SECTION 00911 - ADDENDUM 6

A. Project Name: South Main Corridor Improvement Project

C. Engineer's Project Number: 16-108.

D. Date of Addendum: March 12, 2021

C08.21

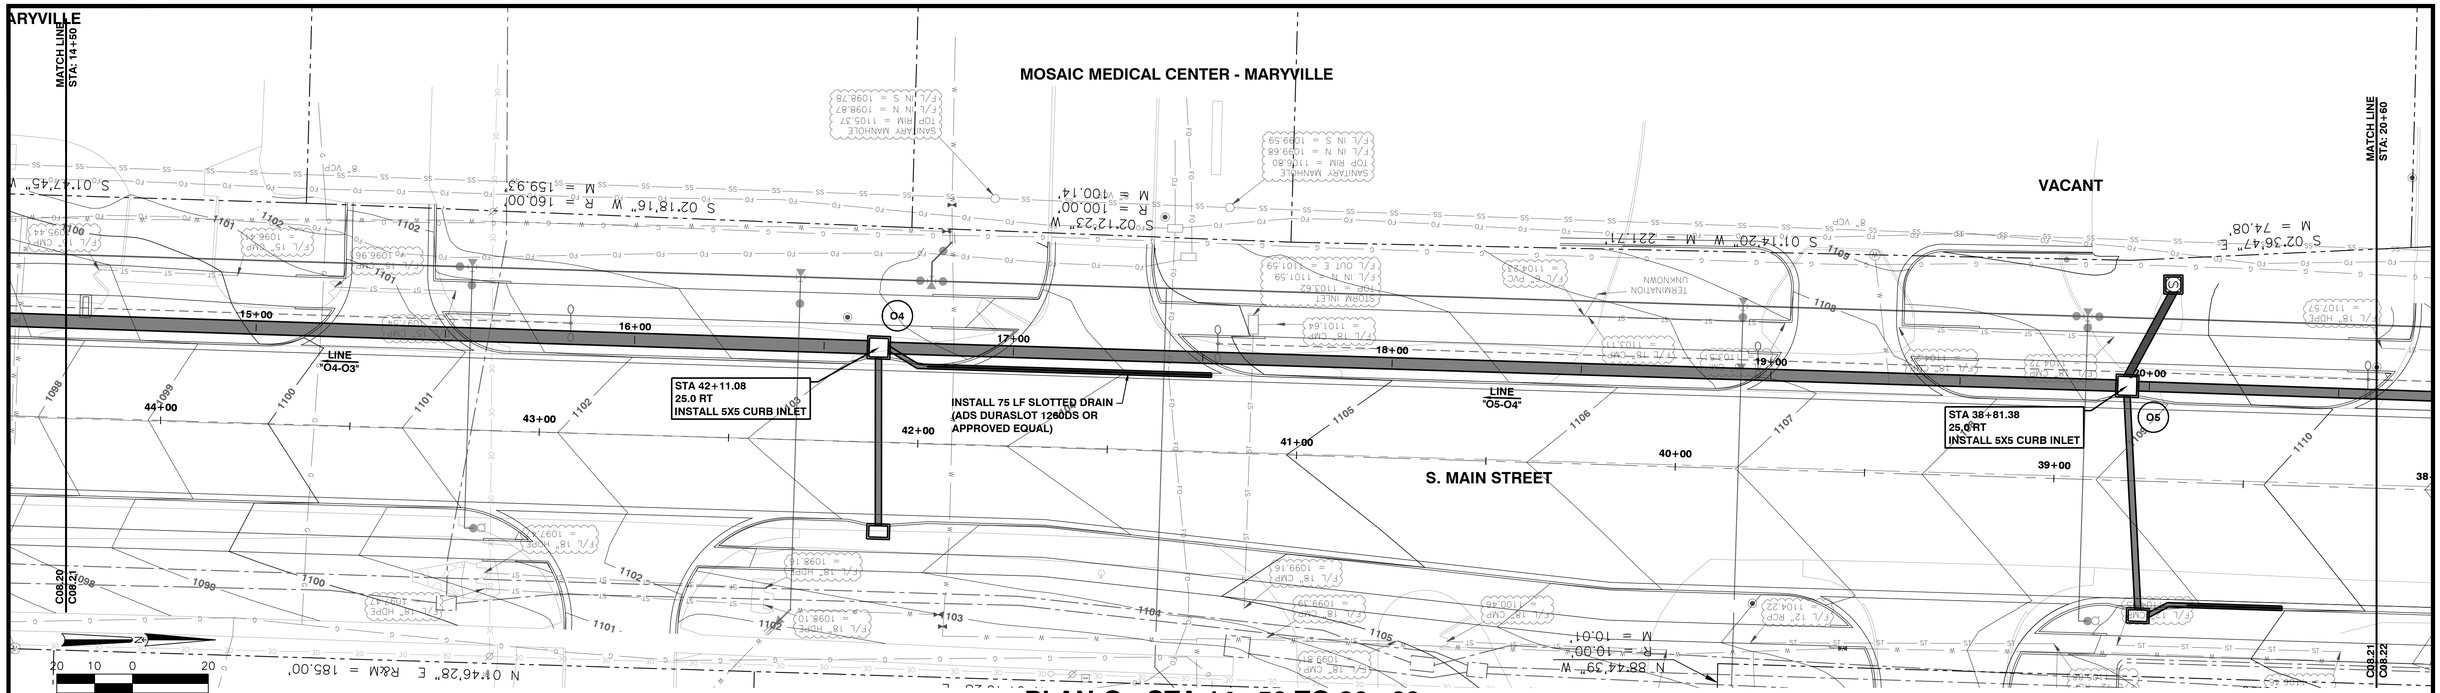
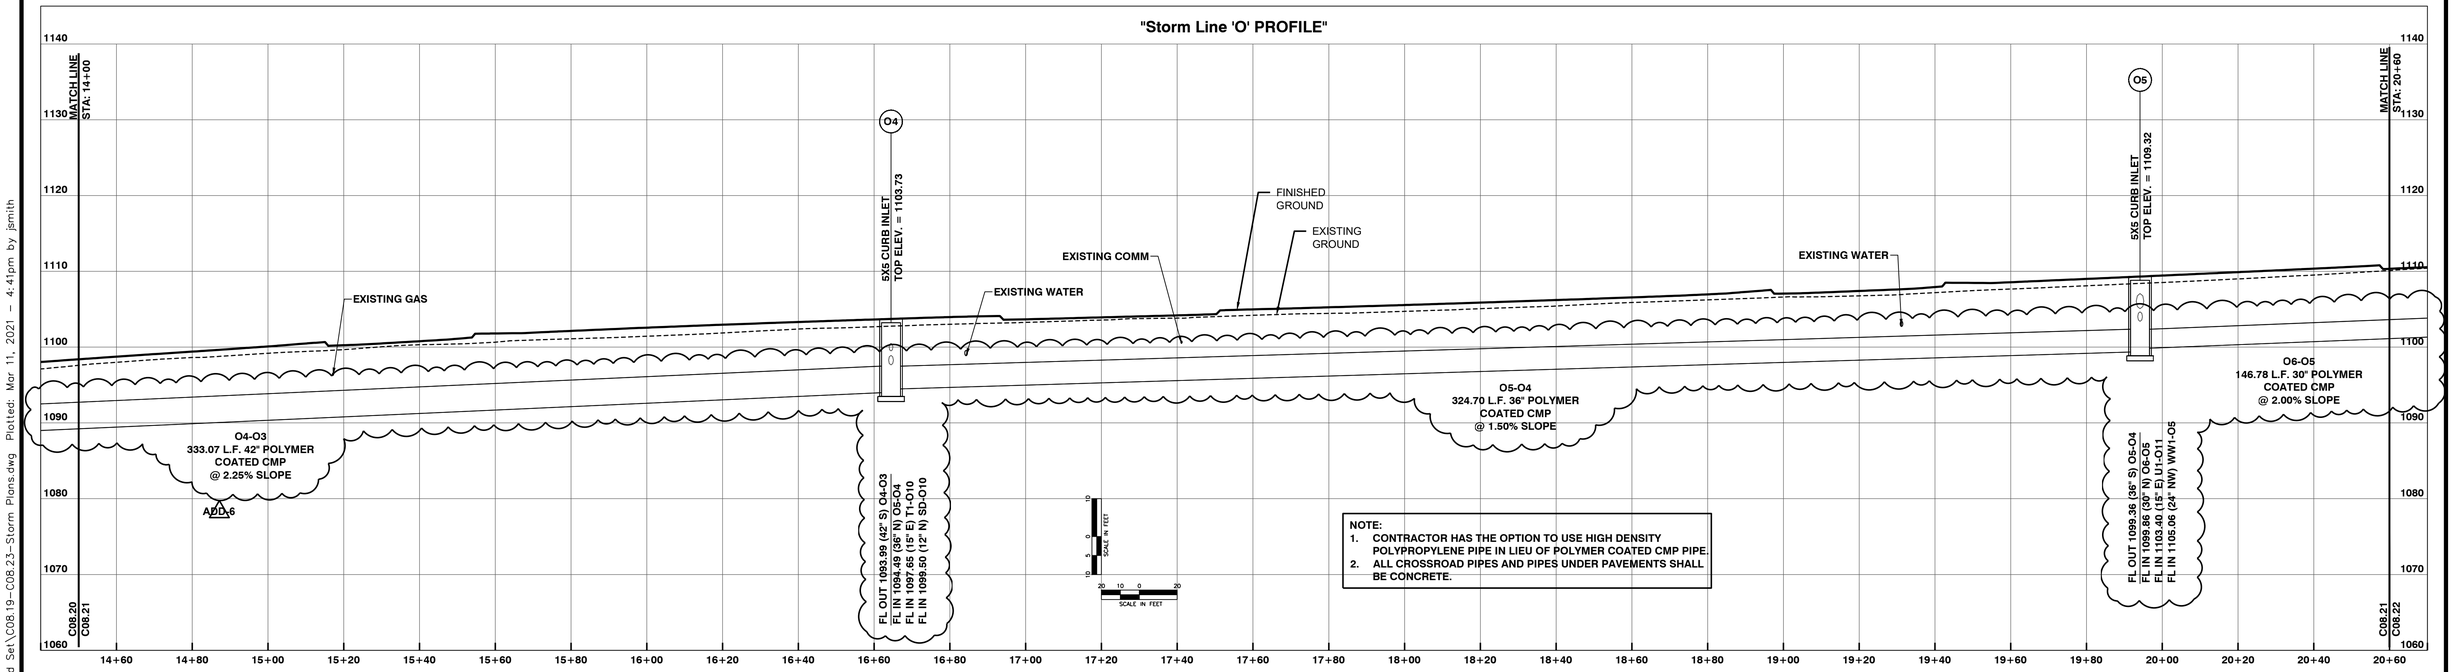
6. Sheet C08.21 - Updated profile as a result of upstream changes to avoid sanitary sewer conflict with pipe C7-C6.
   7. Sheet C08.22 - Updated profile to avoid sanitary sewer conflict with pipe C7-C6.

C08.27

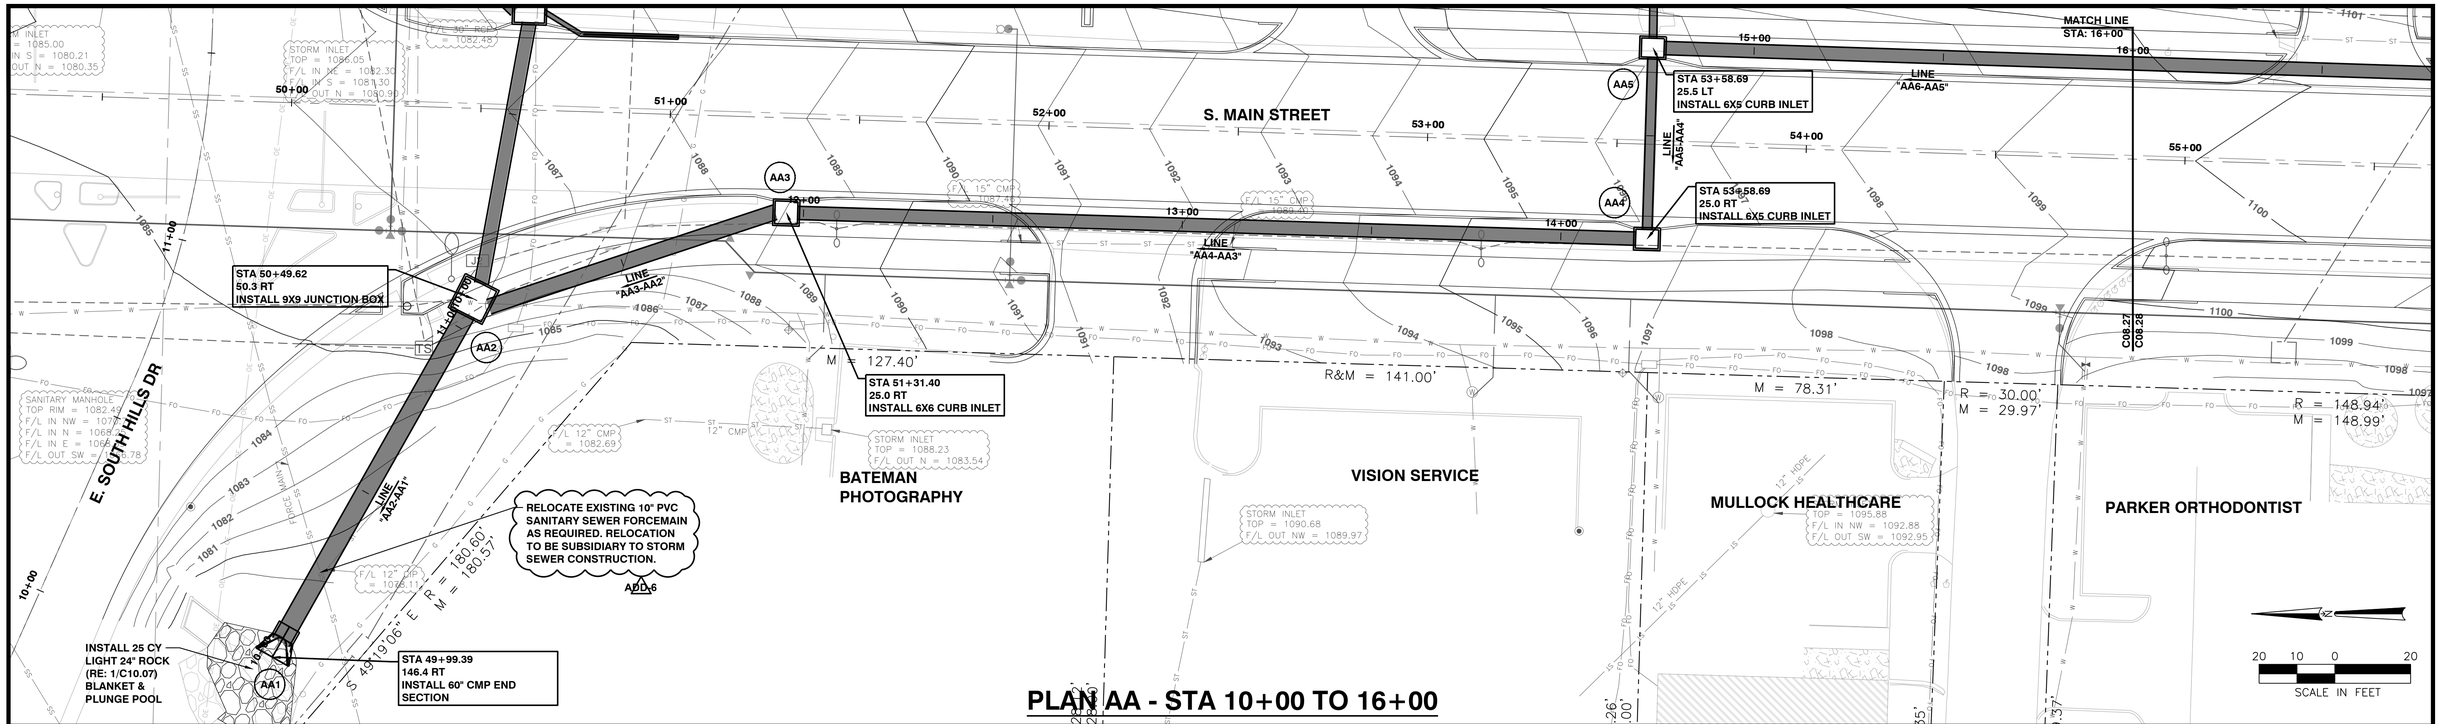
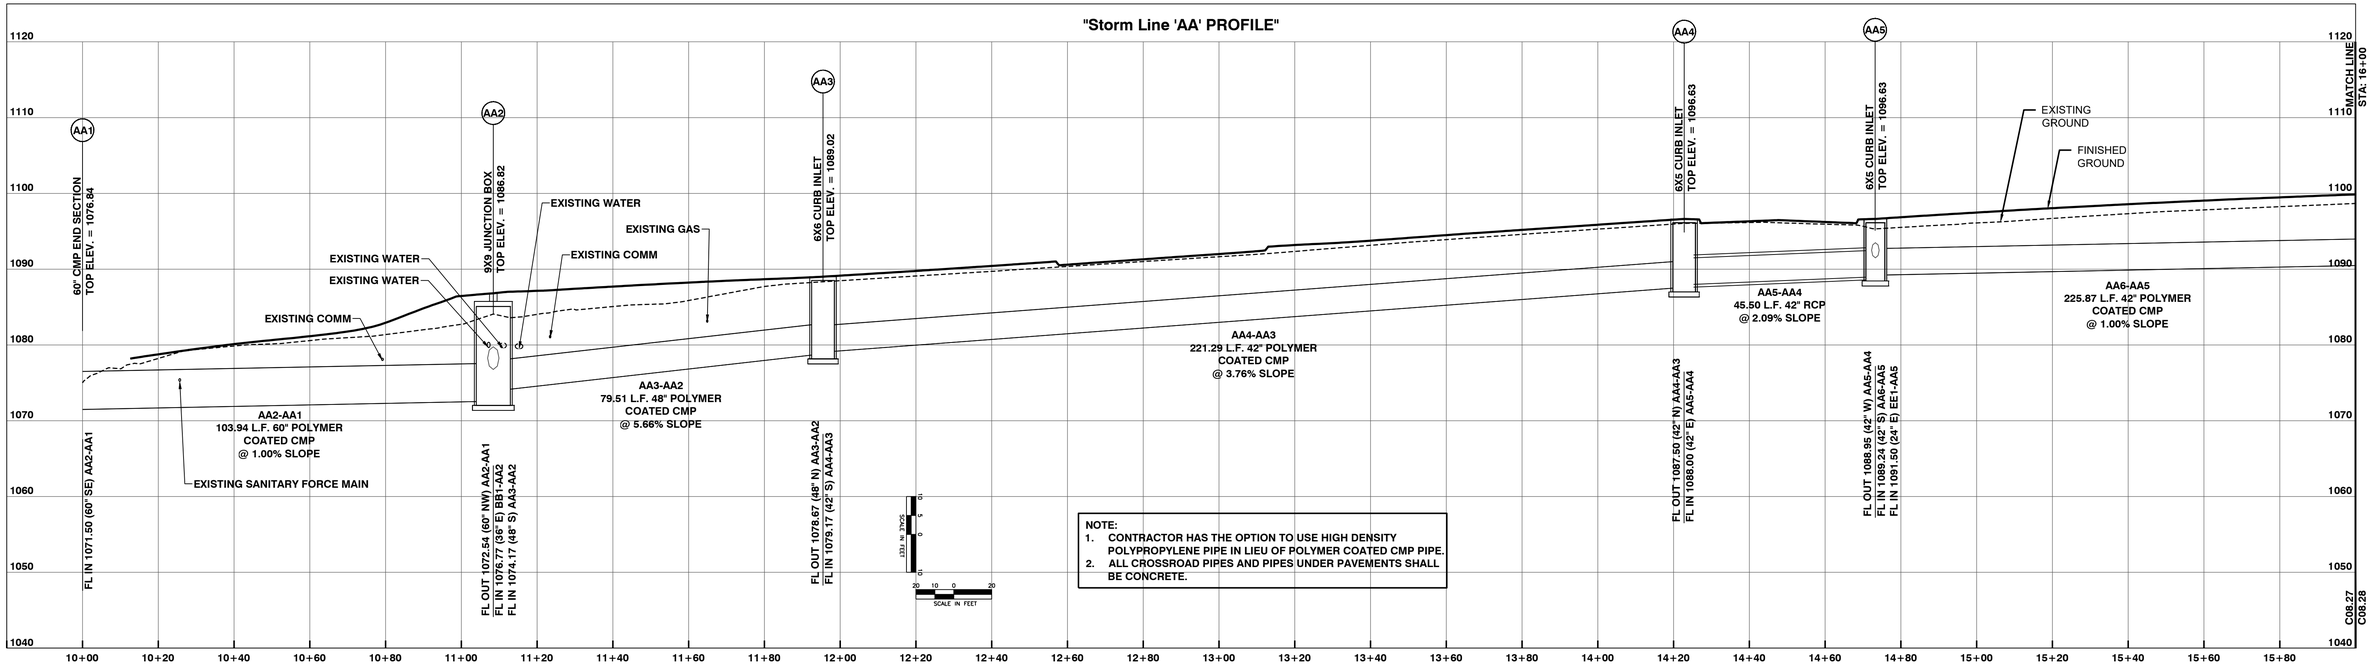
8. Sheet C08.27 - Added note to relocate the existing sanitary sewer forcemain, as required. Cost for relocation is to be subsidiary to storm sewer cost.

WAYFINDING SIGNAGE - FRONT ELEVATION

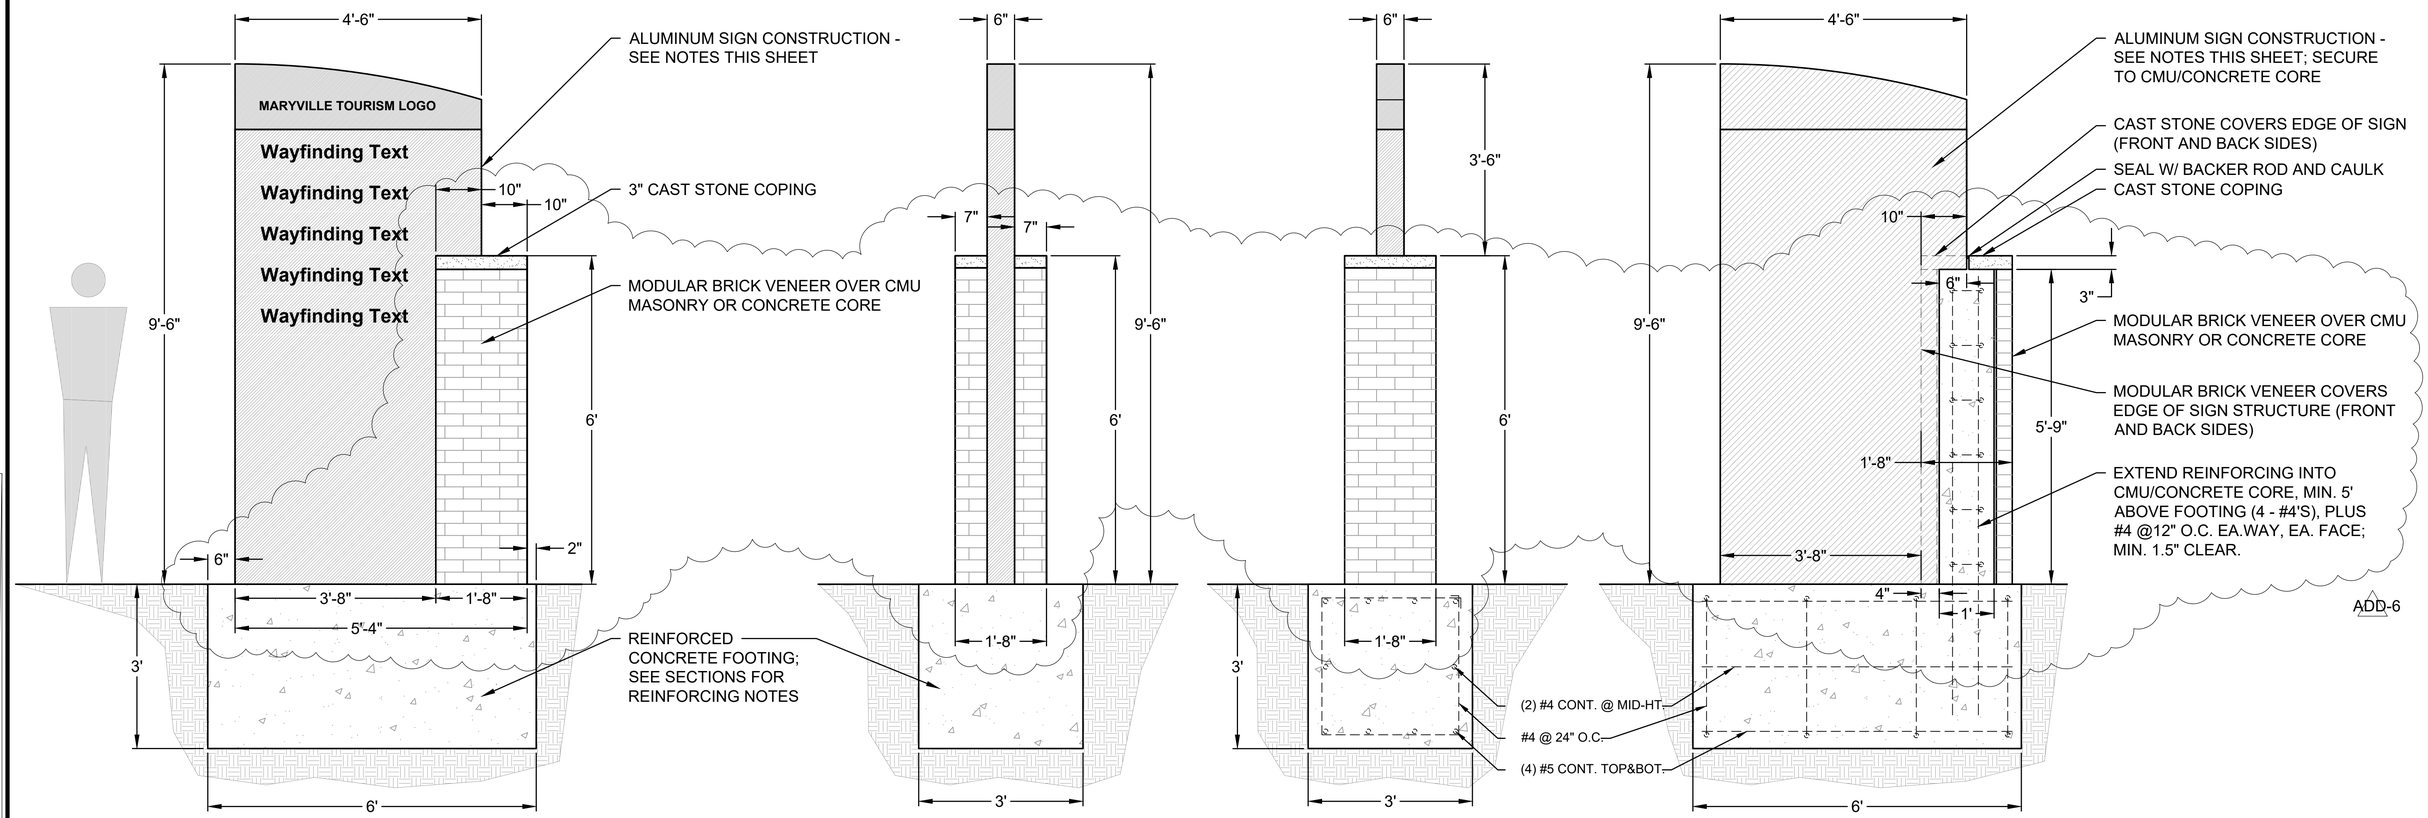
9. Sheets C12.01, C12.11, and C12.21 – Added notes.
   10. Sheet L02.03 – Revised sign column masonry for a full-depth (modular) brick veneer, in lieu of thin-brick. Column dimensions are adjusted, as required, with slight width modifications.

7. PROVIDE 5-YEAR WARRANTY ON THE SIGN STRUCTURE AND GRAPHICS.
8. BRICK VENEER: BRICK SHALL BE "VILLAGE", MODULAR BRICK, VELOUR TEXTURE, BLEND DTP155, ITEM #128469, AS MANUFACTURED BY ACME BRICK, OR APPROVED EQUIVALENT. SUBMIT SAMPLES FOR APPROVAL; ALL EXPOSED BRICK SHALL BE TREATED WITH "SALTGUARD-WB", AS MANUFACTURED BY PROSOCO, OR APPROVED EQUIVALENT, PER MANUFACTURER'S RECOMMENDATIONS.

COMMERCIAL MONUMENT SIGN - FRONT ELEVATION

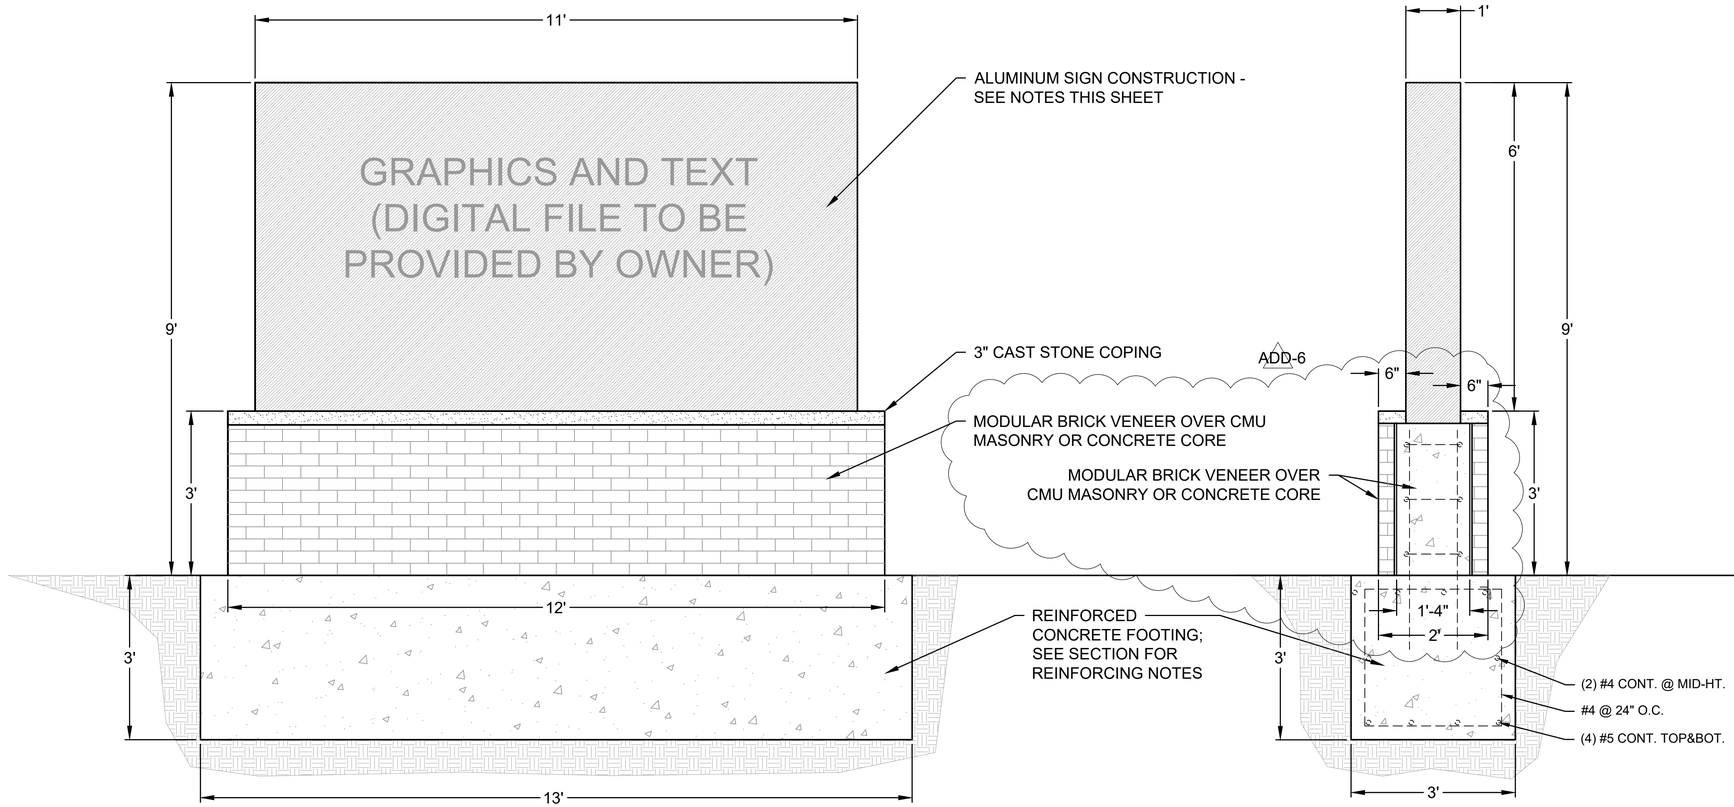
11. Sheet L02.05 – Revised sign base masonry for a full-depth (modular) brick veneer, in lieu of thin-brick. Base section dimensions are adjusted, as required. Revised reference to sign graphics provided by the owner.

6. THE SIGN GRAPHICS SHALL BE AN APPLIED DIGITAL PRINT ON 3M-IJ-180C VINYL WITH A UV LUSTER LAMINATE COVER. THE OWNER WILL PROVIDE A DIGITAL FILE OF THE GRAPHICS AND TEXT, FOR USE BY THE FABRICATOR. ADD-6

7. PROVIDE 5-YEAR WARRANTY ON THE SIGN STRUCTURE AND GRAPHICS.
8. BRICK VENEER: BRICK SHALL BE "VILLAGE", MODULAR BRICK, VELOUR TEXTURE, BLEND DTP155, ITEM #128469, AS MANUFACTURED BY ACME BRICK, OR APPROVED EQUIVALENT. SUBMIT SAMPLES FOR APPROVAL; ALL EXPOSED BRICK SHALL BE TREATED WITH "SALTGUARD-WB", AS MANUFACTURED BY PROSOCO, OR APPROVED EQUIVALENT, PER MANUFACTURER'S RECOMMENDATIONS. ADD-6
